Land at Gosford

Technical Note 11: Response to Oxfordshire County Council (OCC)

22nd June 2023

Articulated Vehicle Entry South
1:500

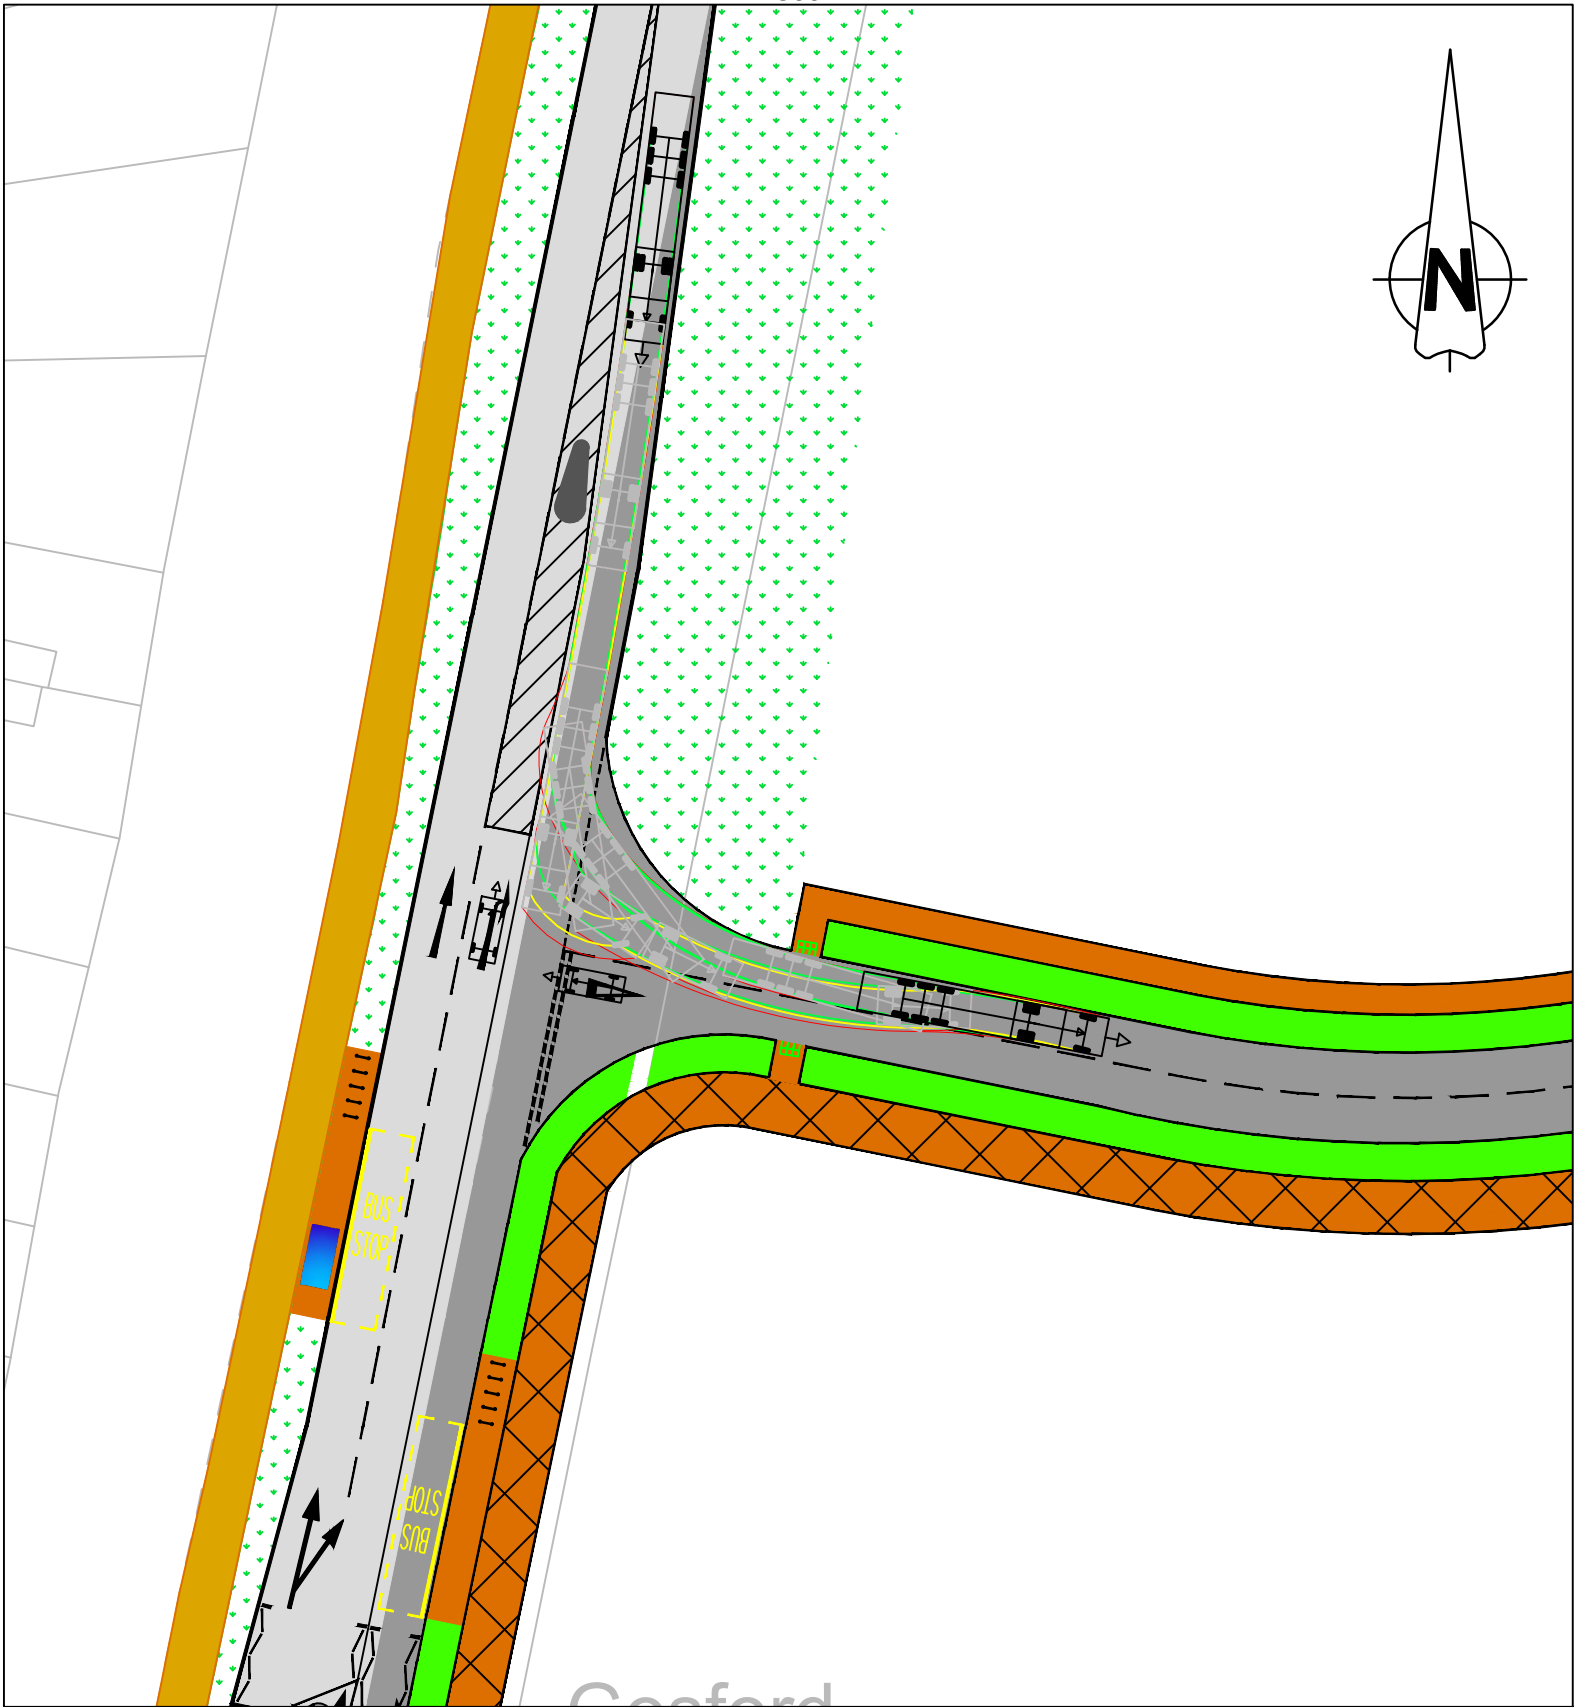
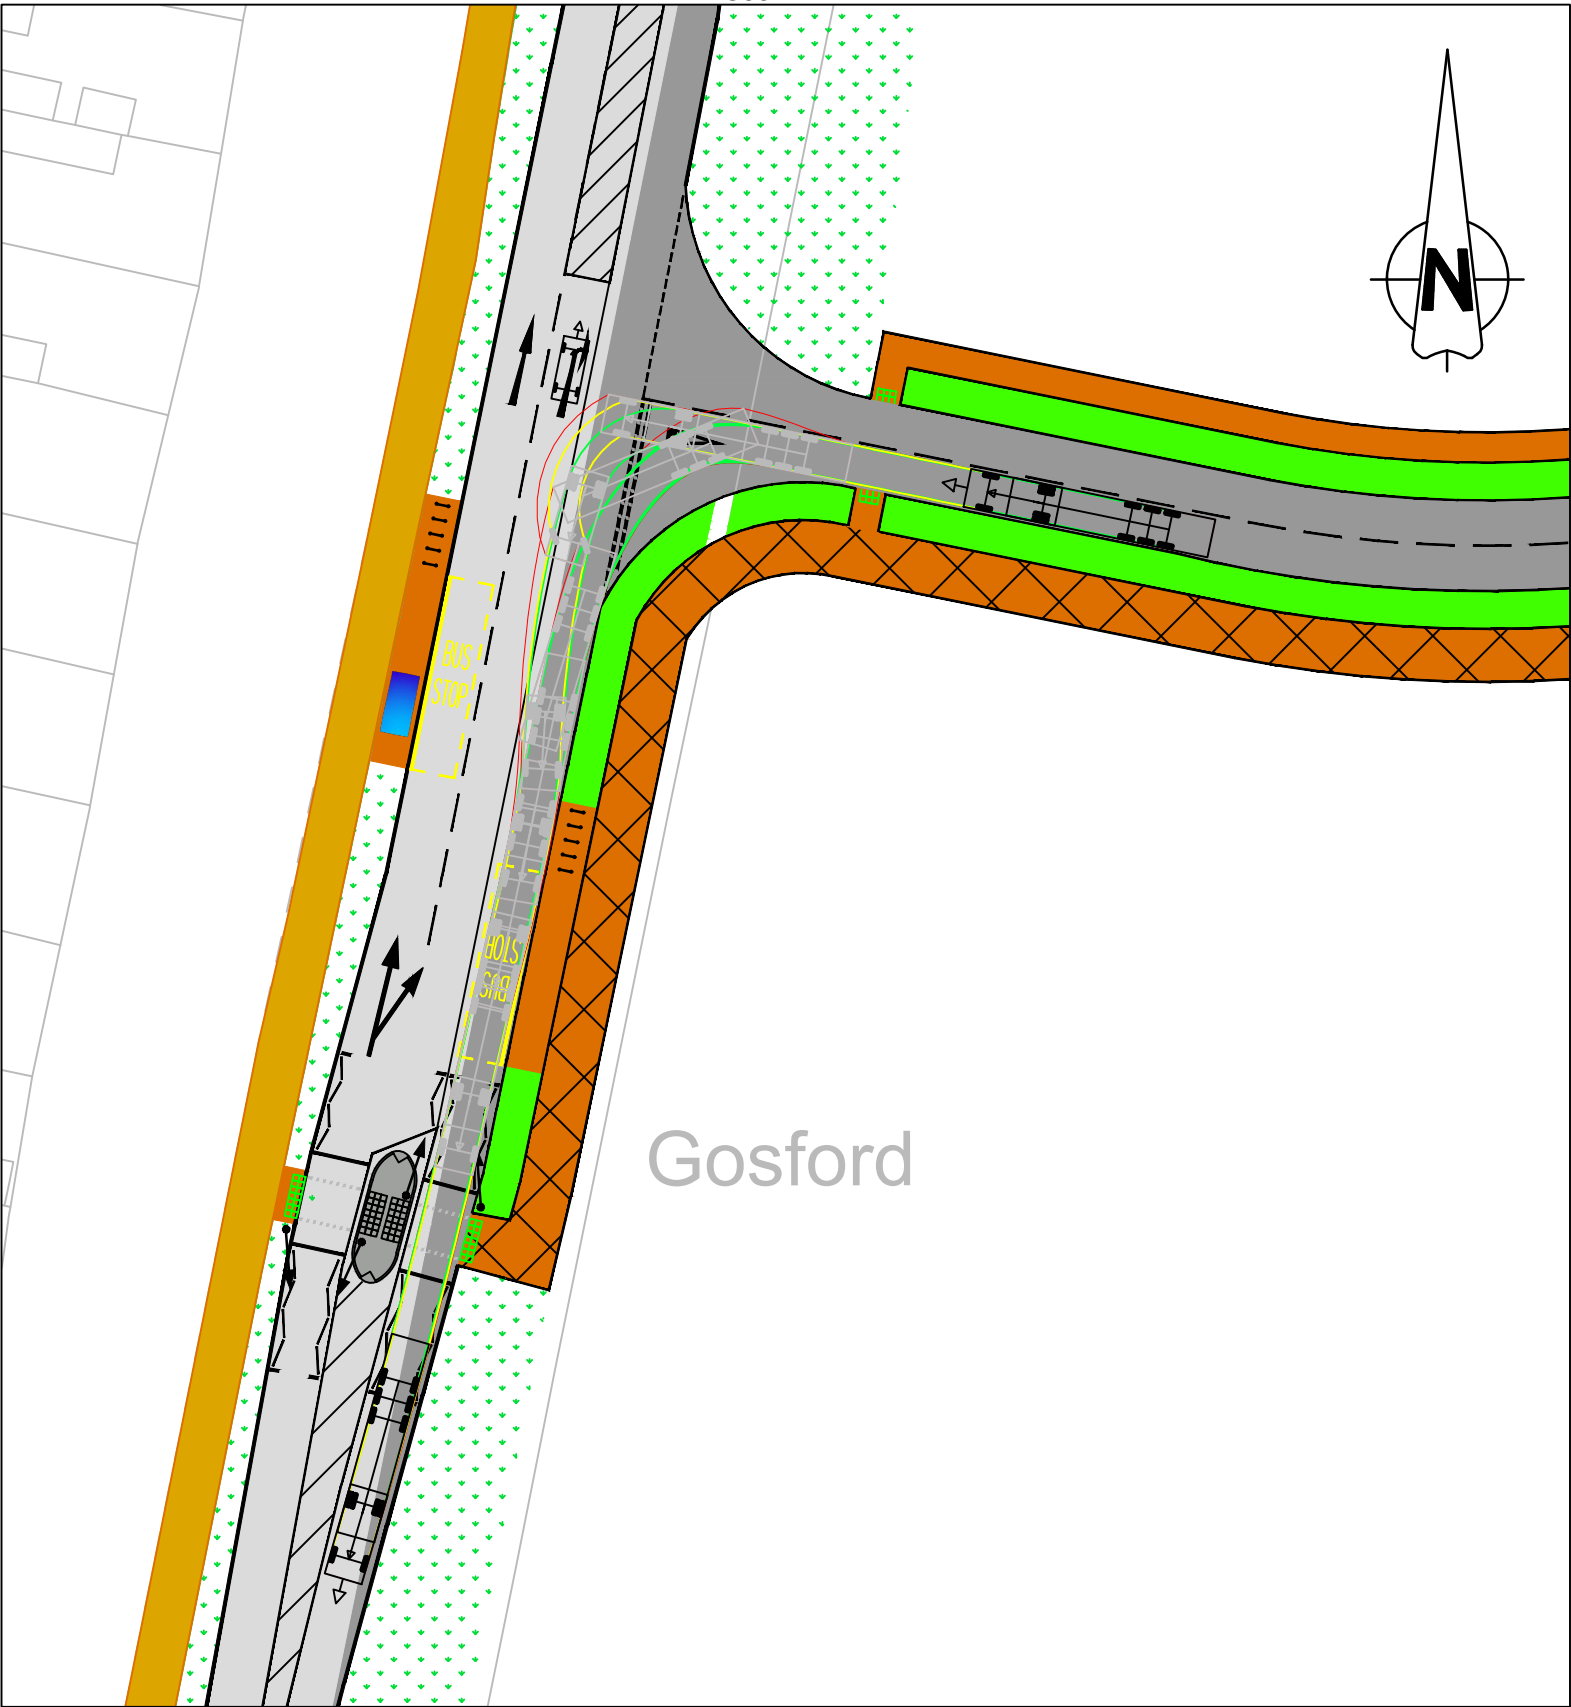
OCC Comment: Para 4.4 mentions a swept path exercise that has been undertaken at the access points to ensure/ demonstrate that the development can be safely served by large vehicles. It goes on to state that the swept path details are provided in Appendix D. Interrogation of the TA and indeed other documents fails to reveal the swept path drawings at any of the site accesses. The swept path drawings must be submitted to show that the site accesses can safely accommodate expected vehicles.

- 3.5** This is noted and the drawings are contained in **Appendix C**.

| Appendix D – Walking / Cycling Routes

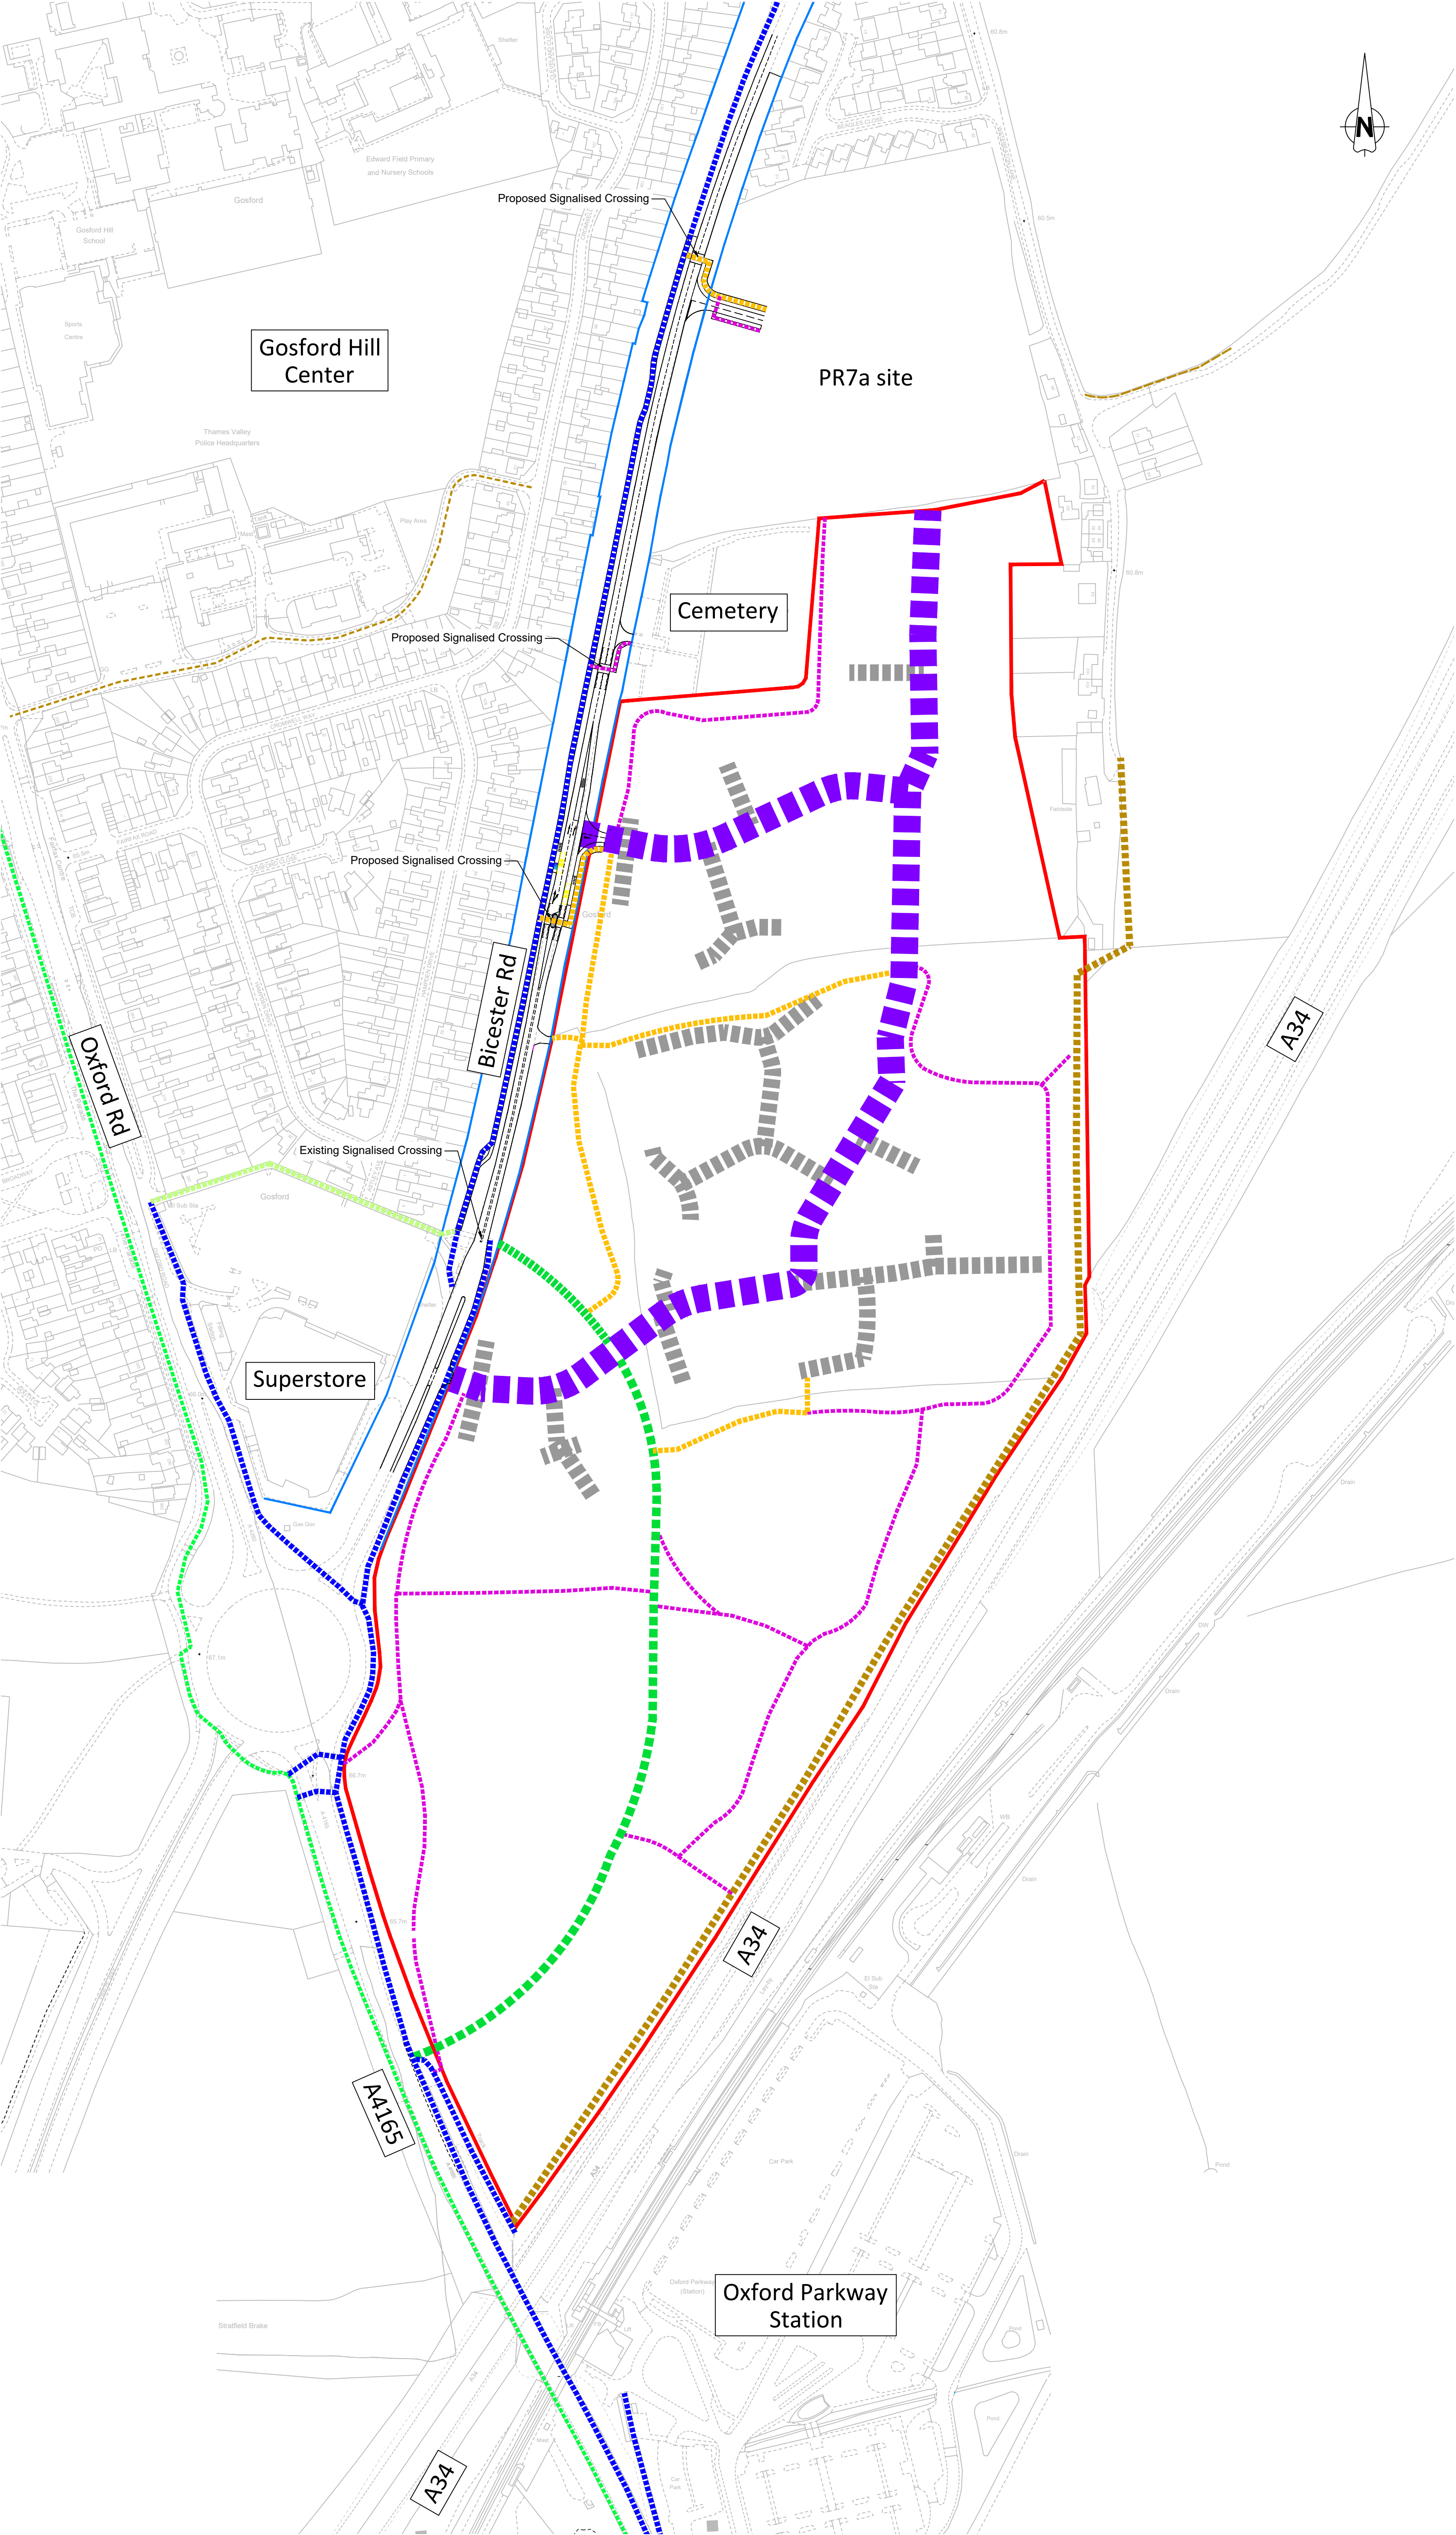
OCC Comment: The application needs to clearly illustrate how the Greenway and the PRoW will tie-in to the existing shared pedestrian/cycleway along Oxford Road. These links to the south of the development would form the most direct and obvious routes to those wishing to walk and cycle to/from Oxford City. And the existing shared path along Oxford Road is not as good as it should be for a main non-motorised route – noted to be only 1.5m wide. enhancements must be made to its width in terms of safeguarding land required to deliver the necessary width compliant of LTN1/20 should there be inadequate highway verge along this frontage. It is therefore requested that 3.5 metres is reserved via s106 agreement for future dedication of land to be used as public highway should the proposed corridor scheme require it.

- 3.8** The masterplan for the development highlights how the walking and cycling routes combine to provide a comprehensive network. A specific walking and cycling route drawing is contained in **Appendix D**. The request for land to be dedicated as public highway is noted and can form part of the section 106 discussions.
